ADDENDUM NO. 3

**IMPROVEMENTS TO BAYVIEW PARK, HIGHLAND AVENUE SIDEWALK
IMPROVEMENTS, AND IMPROVEMENTS TO THE LILLIAN GREGERMAN BANDSHELL
WAREHAM, MA**

Bid #1048

February 1, 2024

1 ADA RAMP WITH STAINLESS STEEL HANDRAIL
 NOT TO SCALE

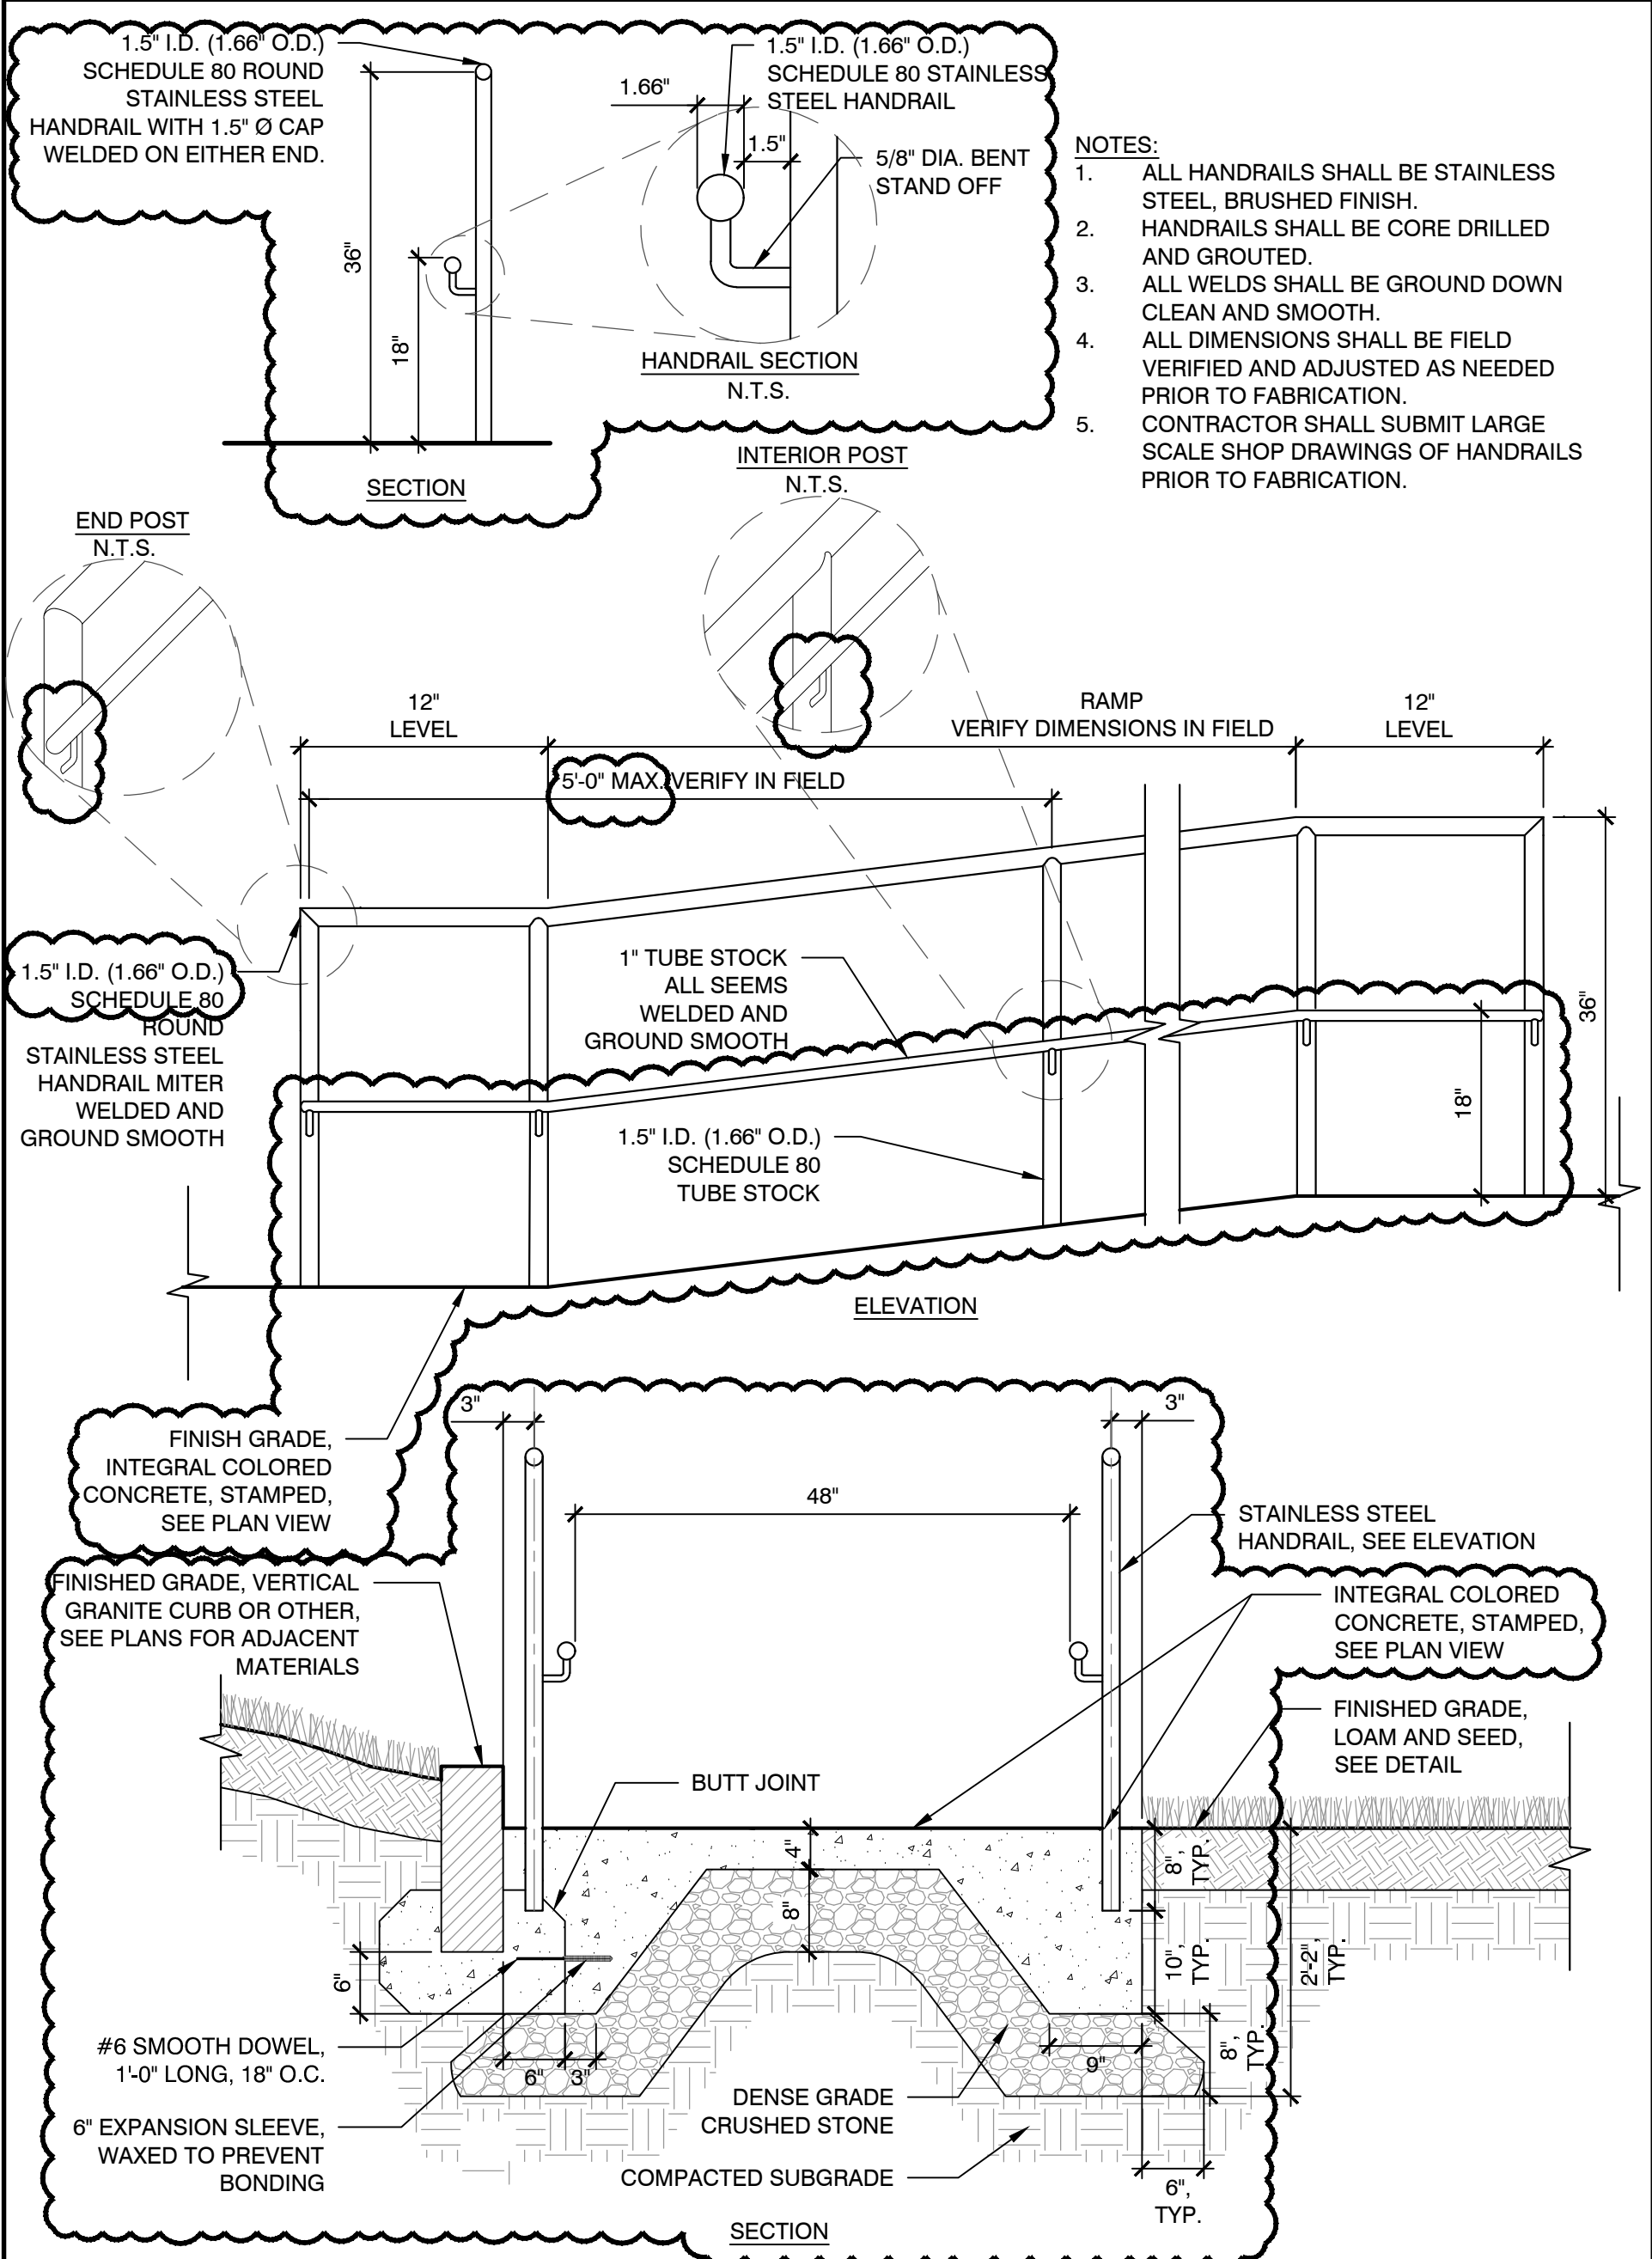
1. **DELETE:** Detail 2, Sheet L504

REPLACE: Detail 2, Sheet L504 in SK-4 per attachment

2. **DELETE:** Detail C, Sheet A-1.3

REPLACE: SK-4 per attachment with the following modifications:

- Delete callout: FINISH GRADE, INTEGRAL COLORED CONCRETE, STAMPED, SEE PLAN VIEW

- Replace with callout: FINISH GRADE, CAST-IN-PLACE CONCRETE, SEE PLAN VIEW
 - Delete callout: INTEGRAL COLORED CONCRETE, STAMPED, SEE PLAN VIEW
 - Replace with callout: CAST-IN-PLACE CONCRETE, SEE PLAN VIEW

Answer: **Yes, the ADA ramp (Detail 2, L504) at Bayview Park shall be integral colored concrete, stamped. See SK-4 per attachment.**

Question 9: The Handrails for the ADA Ramp shown in Detail 2 on sheet L504 are not to code. I have attached the state requirements for ADA handicap ramps and railings. Can you please forward to the architect to clarify the required handrail design?

Answer: **Revisions to the handrail detail can be found in SK-4 which is attached. These revisions apply to all handrails noted on the plans.**

1 CONSTRUCTION ENTRANCE
NOT TO SCALE

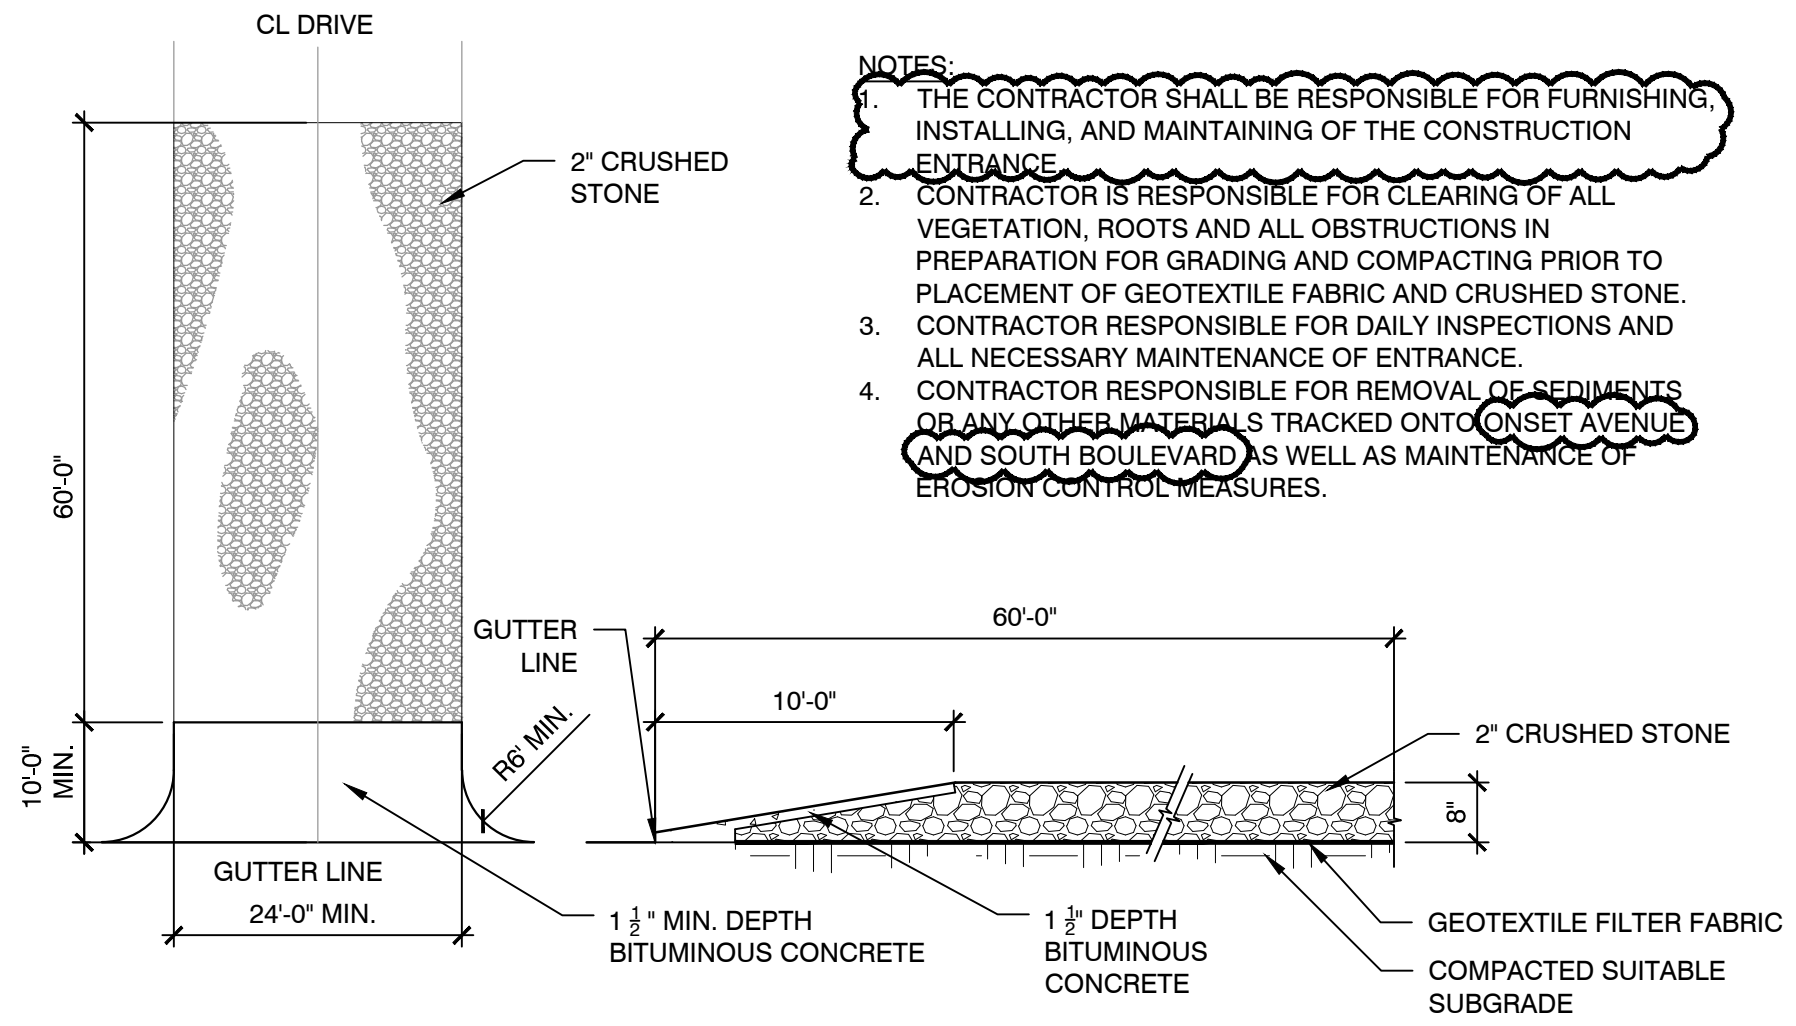
3. **DELETE:** Detail 1, Sheet L500
- REPLACE:** Detail 1, Sheet L500 in SK-5 per attachment
4. On Sheet L110, **DELETE CALLOUT:** “By Town: Construction Entrance (Detail 1, L500)”

Regarding the construction entrance, the Town shall be responsible for installing the construction entrance. The Contractor shall be responsible for maintaining and removing the construction entrance at project end. The Contractor shall be responsible for adhering to notes included in Detail 1, Sheet L500. Reference to Commonwealth Road in Note #3 shall be replaced with ‘Onset Avenue and South Boulevard,’ per the attached SK-5 included in this addendum.

Answer: **The Contractor is responsible for furnishing, installing, and maintaining the 6’ height construction fencing and the construction entrance.**
